Planning Commission Study Session

SUBJECT: DR19-174, SANTAN PAVILIONS PHASE IX

DR19-174, SanTan Pavilions Phase IX: site plan, landscape, grading and drainage, elevations, floor plans, lighting, colors and materials for approximately 3.7 acres, generally located west of the southwest corner of Santan Village Parkway and Williams Field Road and zoned Regional Commercial (RC)

Major A + Shops A & B
elevations

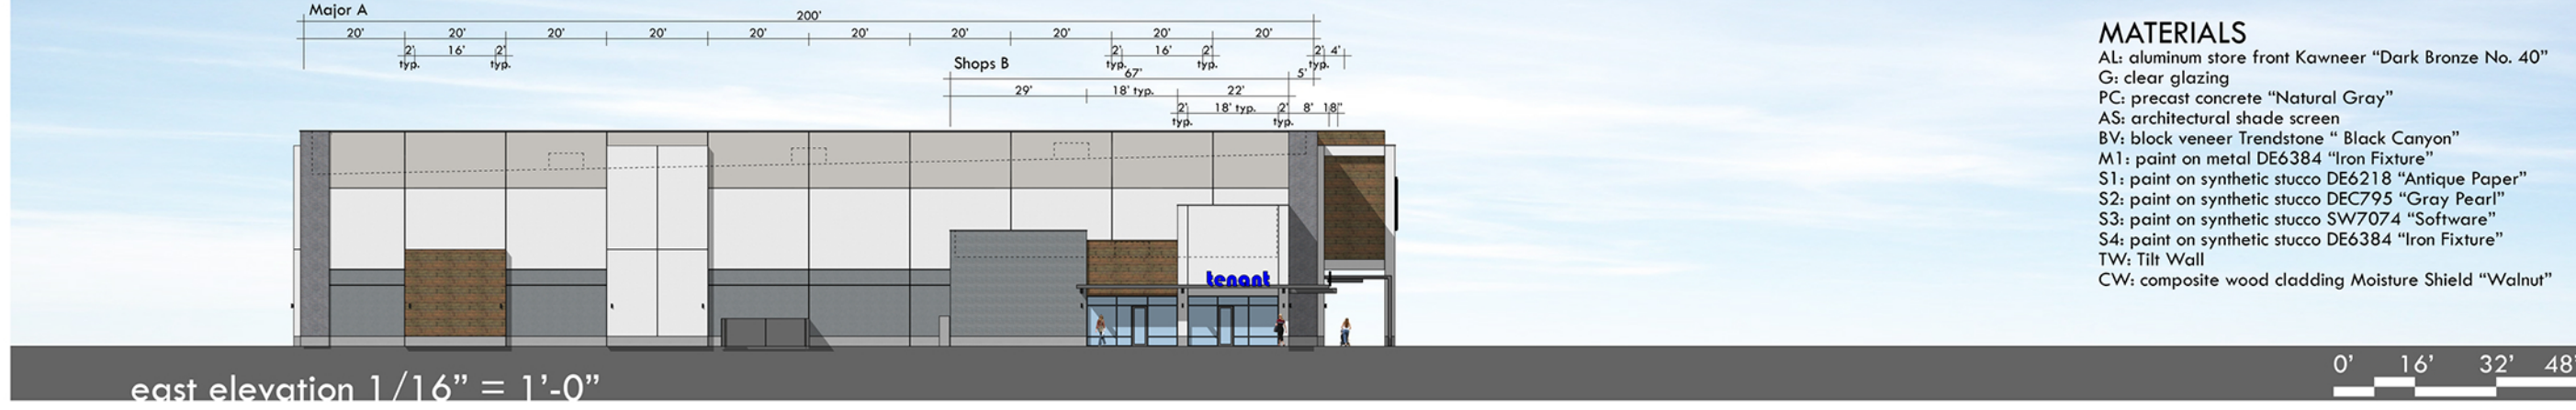
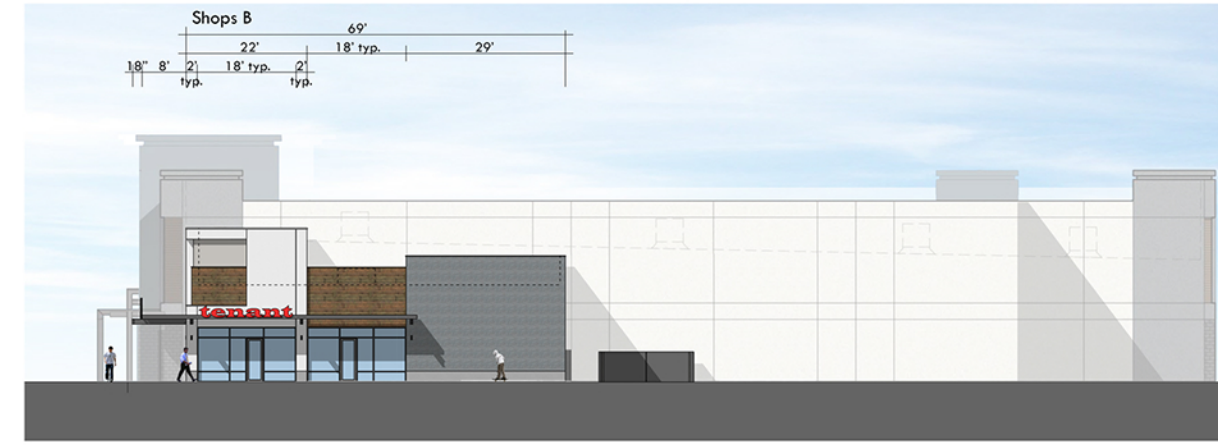
The elevations are consistent with other buildings throughout the project Phases I-VIII. The architecture design motif sets a stage for multiple tenant identities within an organized framework of materials and forms. Though there is no strong reference to historical style, the building designs nonetheless embrace many timeless qualities that appeal to human interaction and scale. The two shop buildings have articulation along elevations that are not against adjacent buildings, utilizing all materials and colors from the master site plan approval. A shaded walkway will be provided along the store fronts, wrapping the north and east/west elevations of each shops building. Staff has worked with the applicant on addressing the articulation of Major A while keeping the big box space structure. Major A is utilizing various materials and colors popped out from the horizontal plane of the building to provide movement and articulation. The main entrance is projected 16' from the building with shade canopies flanking both sides along the building frontage. The sides and back of Major A use color blocking and pop-out projections, applying wood siding and white stucco at differing parapet heights to break up the building as the two other major users (At Home and Ashley Furniture) have done.

The chosen palette for the center features high quality neutral colors with various accents. Dark bronze window frames are consistent throughout, as is the treatment of exterior metals in dark or light grey paint colors. Natural concrete bases and pre-cast wainscot connect building walls and other features with exterior surfaces. Stucco finishes are consistent throughout in a light and medium gray range. Lastly, the use of a wood-composite material provides the palette with its major color and texture accent. The product is chosen for its color durability and weathering capabilities. *Staff is seeking feedback from the commission if Major A has sufficiently addressed articulation and movement in the building design.*

1. Overall movement and articulation of Major A.
